## ***Interactive comment on “Predicting effects of plantation expansion on streamflow regime for catchments in Australia” by L. Zhang et al.***

Comments from reviewer #1:

**Fig. 1.** Normalising the FDC to achieve common parameter space.

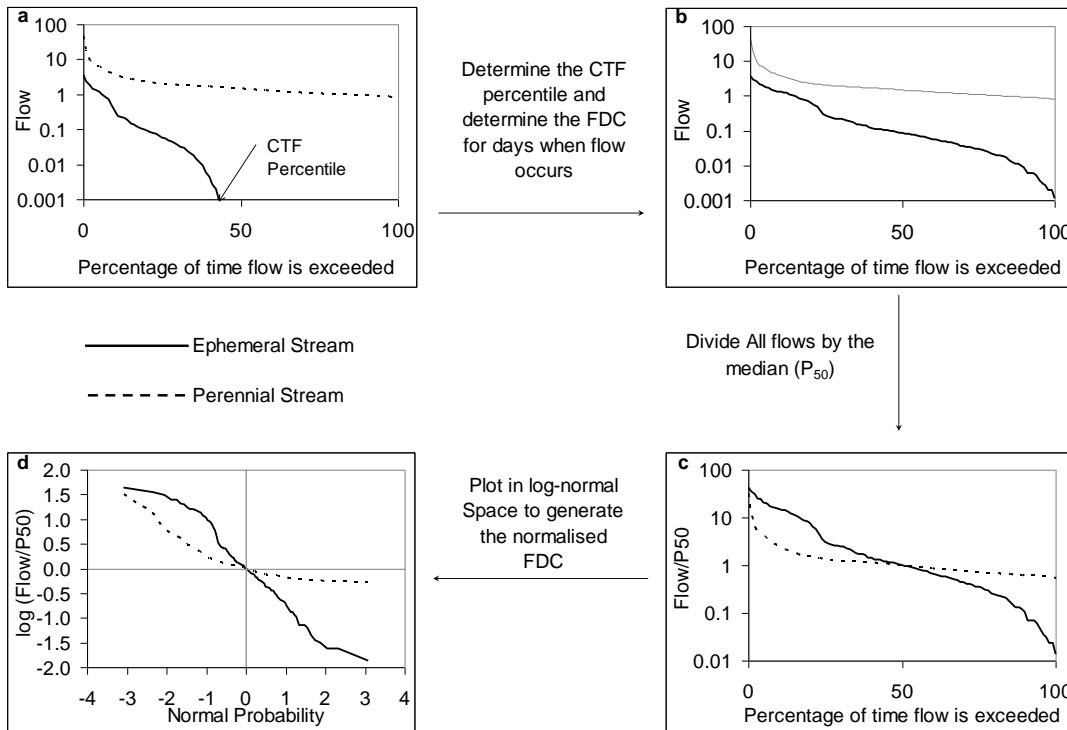
Q8: Technical remarks Please add the sources of Fig. 1 and 2 (FCFC-Manual?). Fig. 3: legend and descriptions are very small.

The FDC within FCFC is represented by a five parameter model in equation (1) as described by Best et al. (2003). The FCFC model normalizes the FDC so that  $Q_{50} = 1$  and  $CTF = 0$  and this facilitates the estimation of the remaining three parameters. Fig. 1 shows the method used to normalise the FDC of perennial and ephemeral streams. Firstly, the cease-to-flow (CTF) percentile is established (Fig. 1a). The CTF percentile is defined as the ratio of the number of non-zero flow days to the total number of days. A non-zero flow day is defined as any day on which flow is greater than or equal to a specified threshold value (adopted here as 0.001 mm/day). A FDC is then constructed using only the days on which flow is greater than the threshold value as streamflow measurements below this value are considered unreliable (Fig. 1b). The FDC is then normalised by dividing all flow values by the conditional median (Fig. 1c). Finally, the FDC is plotted in log-normal space (Fig. 1d) to produce a normalised FDC (NFDC). This normalisation procedure results in all of the NFDCs intersecting the origin.

Response to Q8: Changes have been made as suggested. Section 2.2 has detailed described the FCFC model including the sources of Fig. 1 and Fig. 2. It should be noted that new Fig.2 is used in the revised manuscript. The detailed FCFC model description can be referred from the response to the first comment above. We have also enlarged Fig. 3 to make it clear.
